[Docket No. 97-SW-32-AD; Amendment 39-10520; AD 97-18-11]

Airworthiness Directives; Bell Helicopter Textron (Bell) Model 204B, 205A, and 205A-1 Helicopters

AD 97-18-11 Bell Helicopter Textron: Amendment 39-10520. Docket No. 97-SW-32-AD.

FIG. 7
VIEW LOOKING UP
LEFT SIDE

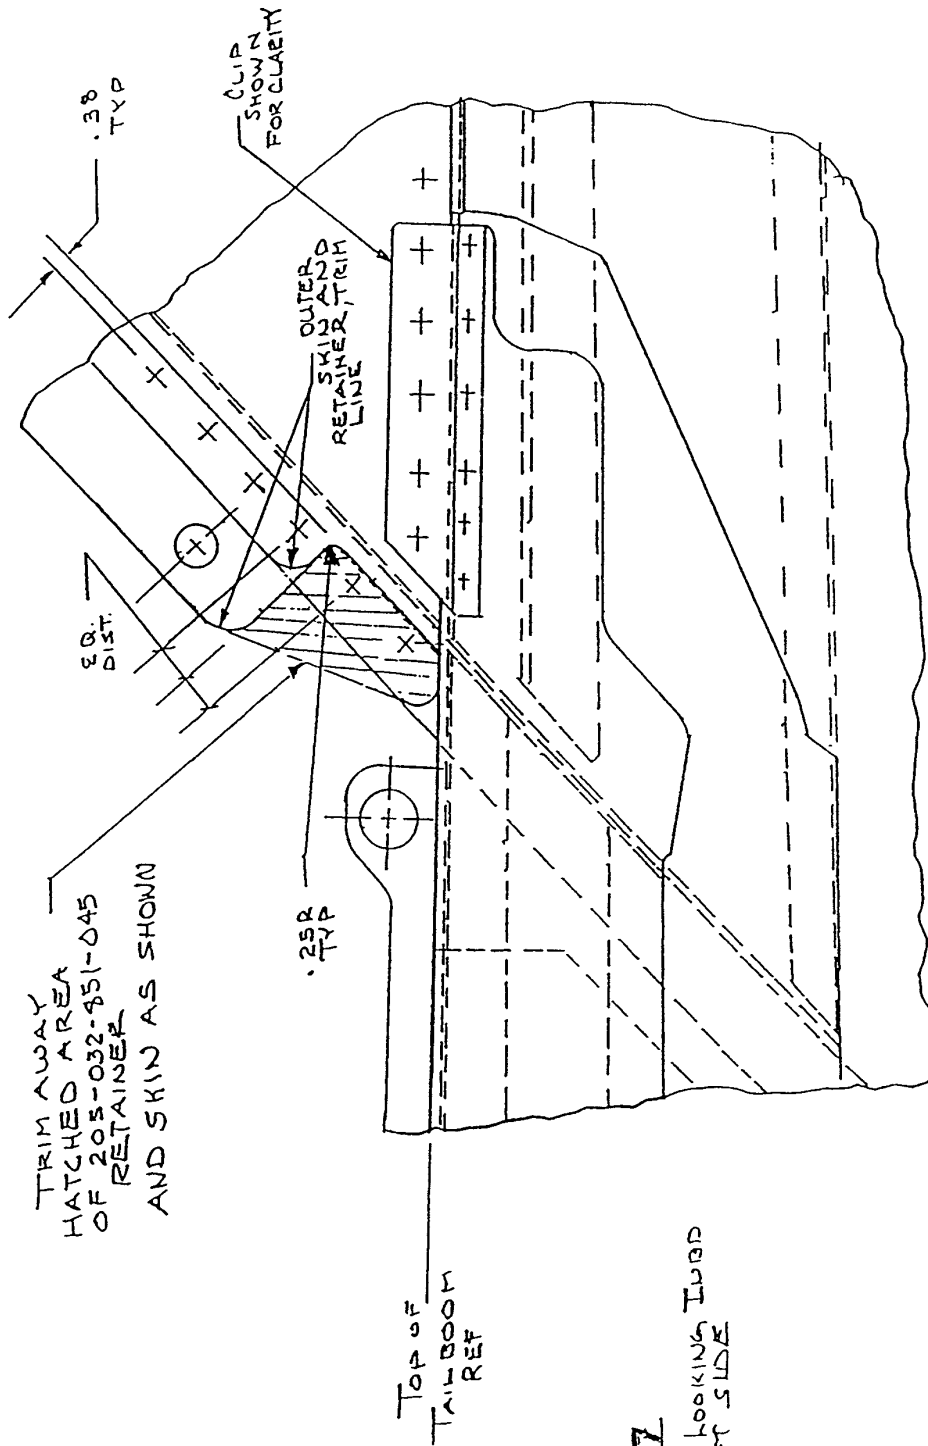
(iii) Trim the vertical fin left-hand side skin and retainer, P/N 205-032-851-045, using extreme care to not damage the vertical fin spar assembly (see Figure 7).
